CITY PLAN COMMISSION**THURSDAY, OCTOBER 19, 2023****FILE NUMBER:** S223-256**SENIOR PLANNER:** Sharmila Shrestha**LOCATION:** between Duncanville Road and Santa Fe Railroad, at the terminus of Ranchero Drive**DATE FILED:** September 20, 2023**ZONING:** IR**CITY COUNCIL DISTRICT:** 3**SIZE OF REQUEST:** 2.722-acres**APPLICANT/OWNER:** Pablo Ramirez**REQUEST:** An application to create one 2.722-acre lot from a tract of land in City Block A/6949 on property located between Duncanville Road and Santa Fe Railroad, at the terminus of Ranchero Drive.**SUBDIVISION HISTORY:**

STAFF RECOMMENDATION: The request complies with the requirements of the IR Industrial/Research District; therefore, staff recommends approval of the request subject to compliance with the following conditions:**General Conditions:**

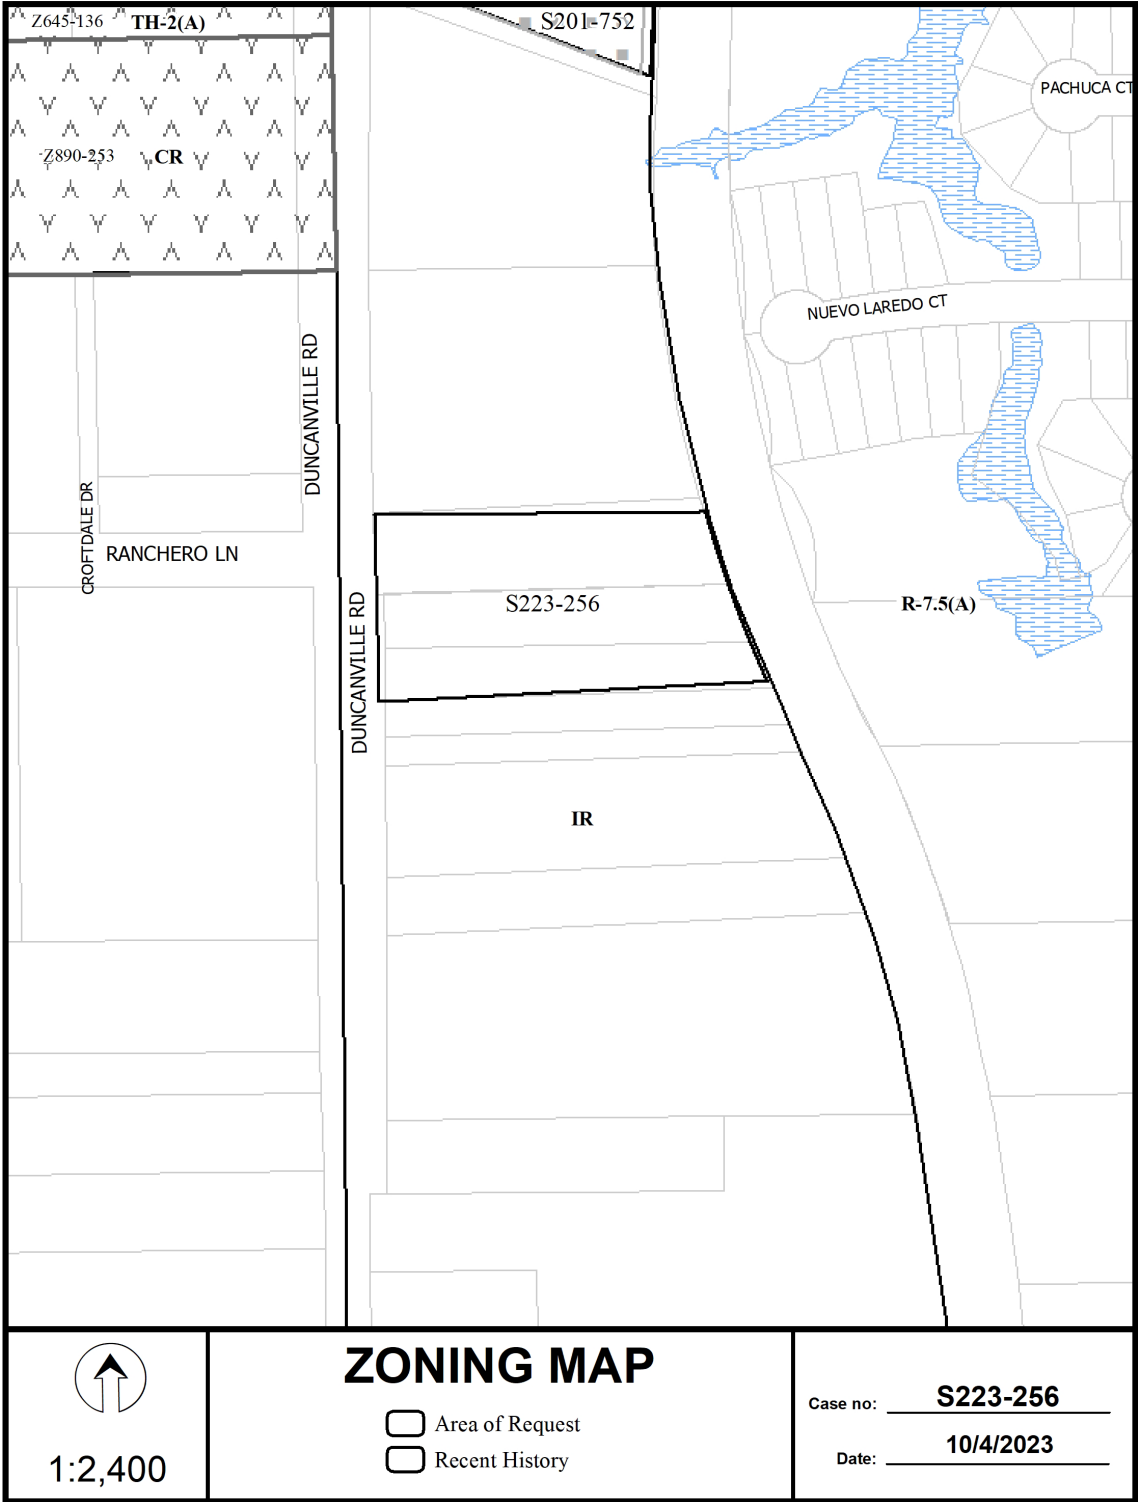
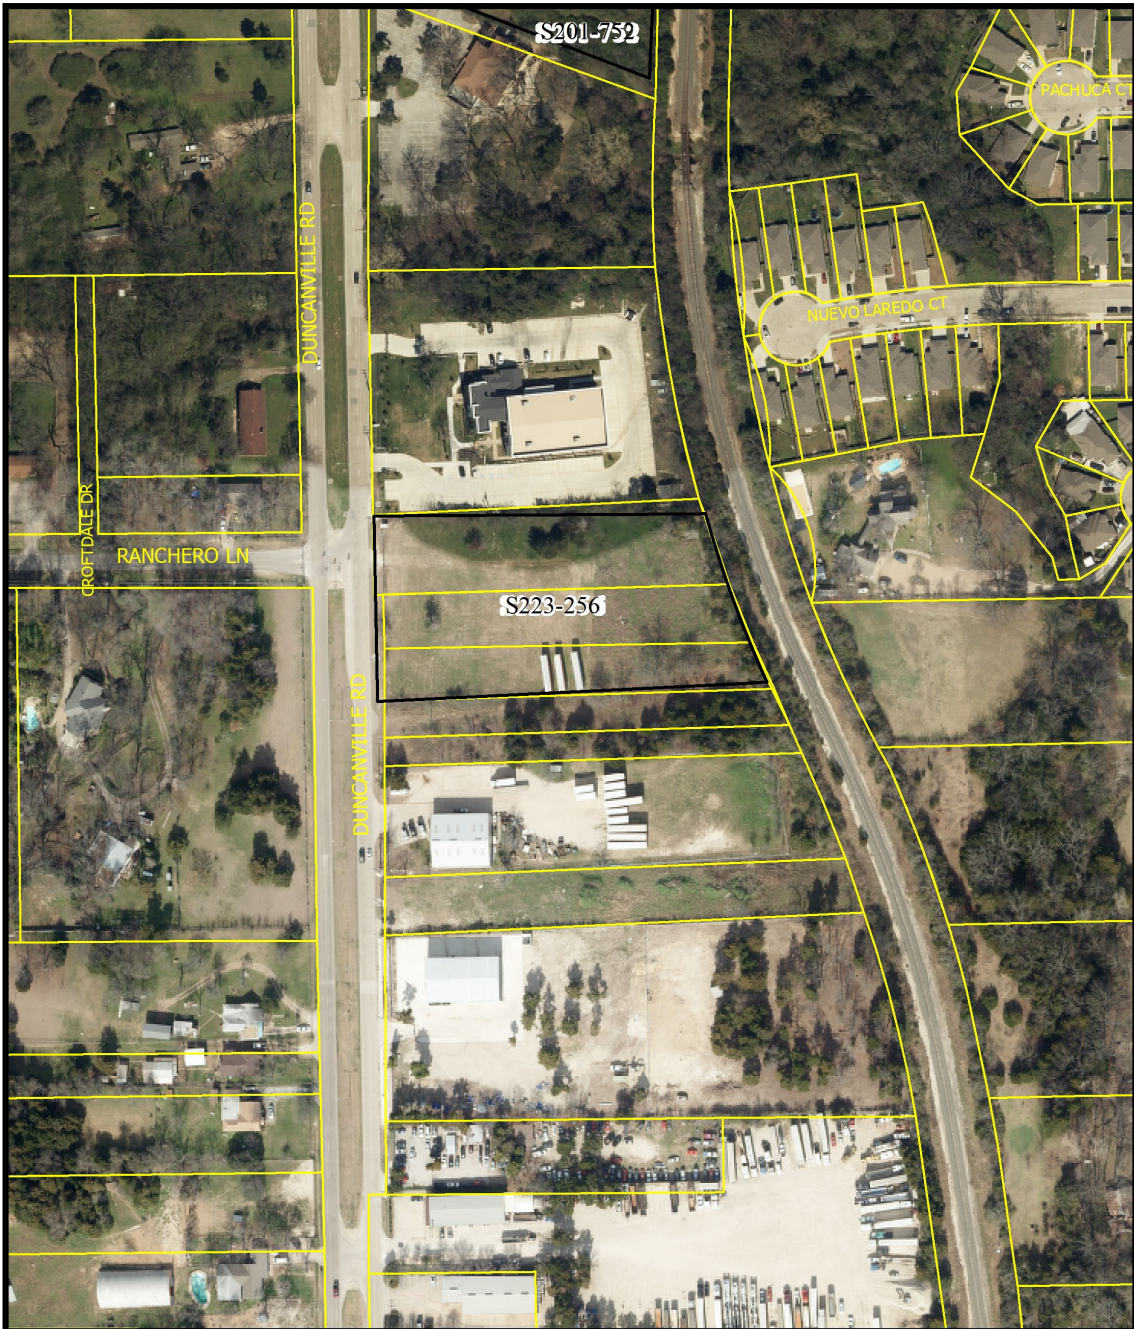
16. Prior to final plat, submit a completed final plat checklist and all supporting documents.
17. On the final plat, show how all adjoining right-of-way was created.
18. On the final plat, show distances/width across all adjoining right-of-way.
19. On the final plat, show recording information on all existing easements within 150 feet of the property.
20. On the final plat, show all additions or tracts of land within 150 feet of property with recording information.

21. Additional design information is required for assessment. Site plan must be submitted showing proposed development, building finished floor elevation, development, existing mains – including downstream manhole, and proposed water and wastewater service locations. Submit water/wastewater engineering plans to 320 E. Jefferson Blvd., Room 200, Attention: Water and Wastewater Engineering.
22. wastewater main improvements are required by Private Development Contract. Submit water/wastewater engineering plans to 320 E. Jefferson Blvd., Room 200, Attention: Water and Wastewater Engineering.
23. Engineer shall furnish plans for water and sanitary sewer. Developer shall furnish a contract for water and sanitary sewer.

24. On the final plat, change “Ranchero Drive” to “Ranchero Drive (F.K.A. Tanzy Road F.K.A. Red Bird Lane)
25. On the final plat, identify the property as Lot 74A in City Block 6949.
